Well Name:	Jicarilla Apache B 15E
Footage:	1135' FSL and 1060' FEL
Location:	SESE Section 30, T24N, R5W
County:	Rio Arriba County, NM
API#:	30-039-27724

Plugging Program for Jicarilla Apache B 15E

Re: Permanent Abandonment Well: 15E Jicarilla Apache B

CONDITIONS OF APPROVAL

Wellbore Diagram Jicarilla Apache B 15E SESE Sec. 30, T24N, R5W Rio Arriba County, NM API #30-039-27724

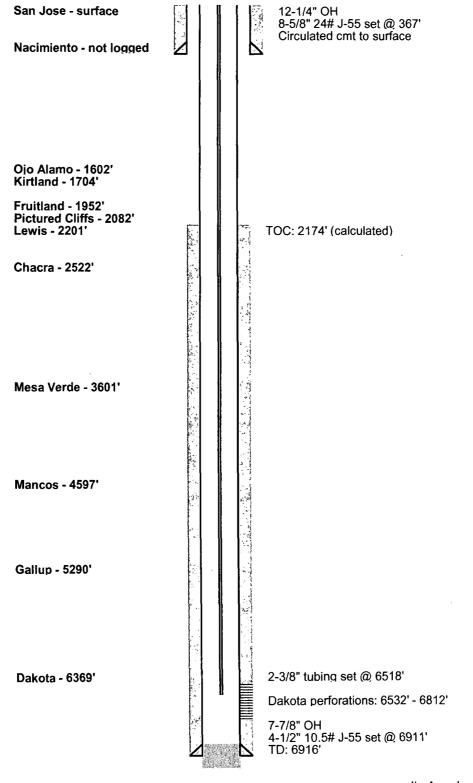
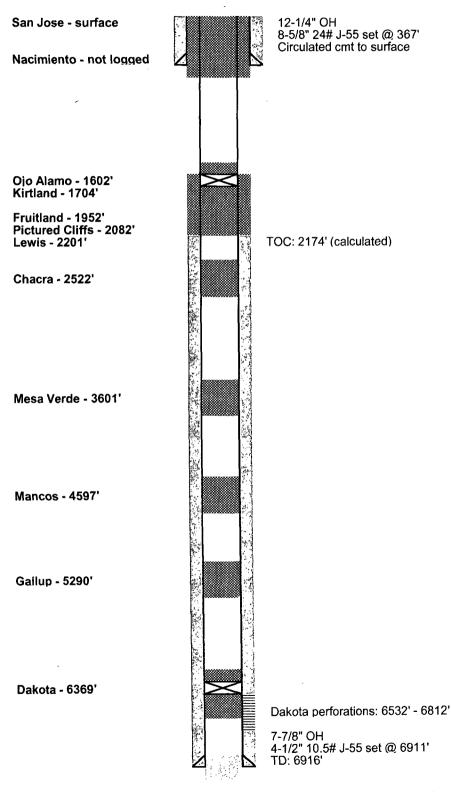
3. The following modifications to your plugging program are to be made:

a) Bring the top of the Dakota plug to 6287'.

b) Place the Gallup plug from 5399' - 5299'.

c) Place the Mancos plug from 4546'- 4446'.

d) Place the Chacra plug from 2940'- 2840'.

e) Place the Pictured Cliffs/Fruitland/Kirtland/Ojo Alamo plug from 2132'- 1490'.

Note: 4 ½" casing was reported circulated to surface. A CBL was run and shows what appears to be ratty cement bond from the Pictured Cliffs to the Ojo Alamo, however a 35/65 poz was run which would make the bonding look this way. Placing cement outside the 4 ½" casing in this interval may not be necessary.
